FORESTSIDE TOWNHOUSES

Issued for : ISSUED FOR SITE INSTRUCTION # 8

SITE INSTRUCTION # 8

JAP Project No: 19066

Date Plotted: Dec 15 2021
Drawn By: ND
Checked By: JW
Job No: 19066
Date: Dec 15 2021
Scale: 1 : 25
Revision Number:
Sheet No: S-201

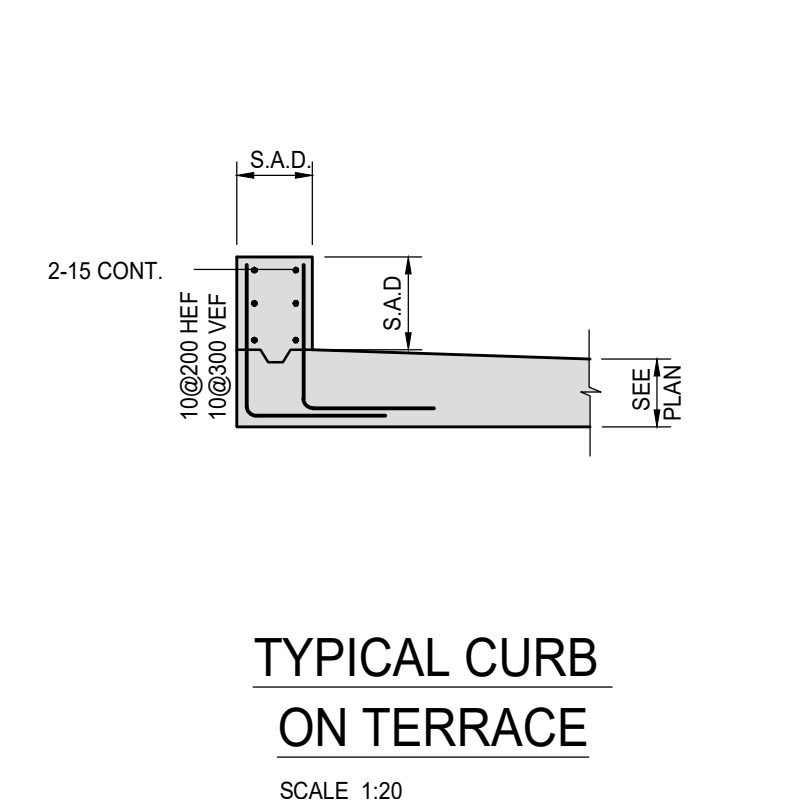
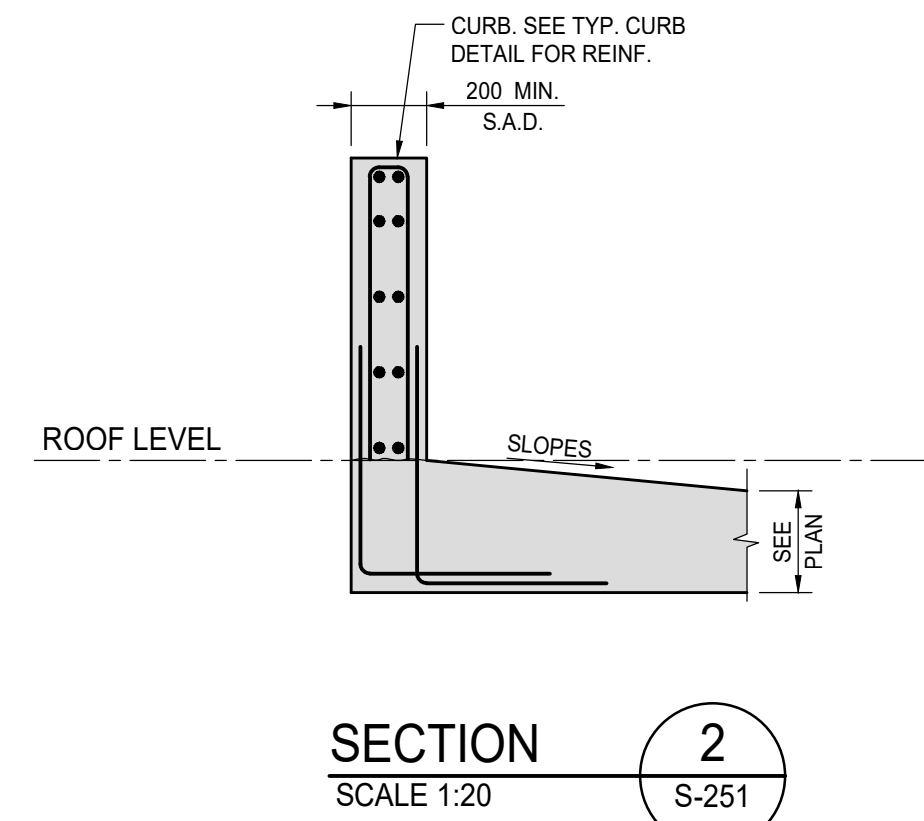
- 1.1 **Refer to Drawing S-102A "GROUND FLOOR FRAMING PLAN"**
 - a) Updated section at slab edge to match as built condition
- 1.2 **Refer to Drawing S-102B "GROUND FLOOR FRAMING PLAN"**
 - b) Updated bubbled area to match slab edge
- 1.3 **Refer to Drawing S-103B "2ND FLOOR FRAMING PLAN"**
 - c) Updated hanging stair box detail and rebar,
 - d) Added section as bubbled
- 1.4 **Refer to Drawing S-201 "SECTIONS"**
 - e) Updated bubbled sections to match as built condition,
- 1.5 **Refer to Drawing S-251 "SECTIONS"**
 - f) Updated bubbled sections
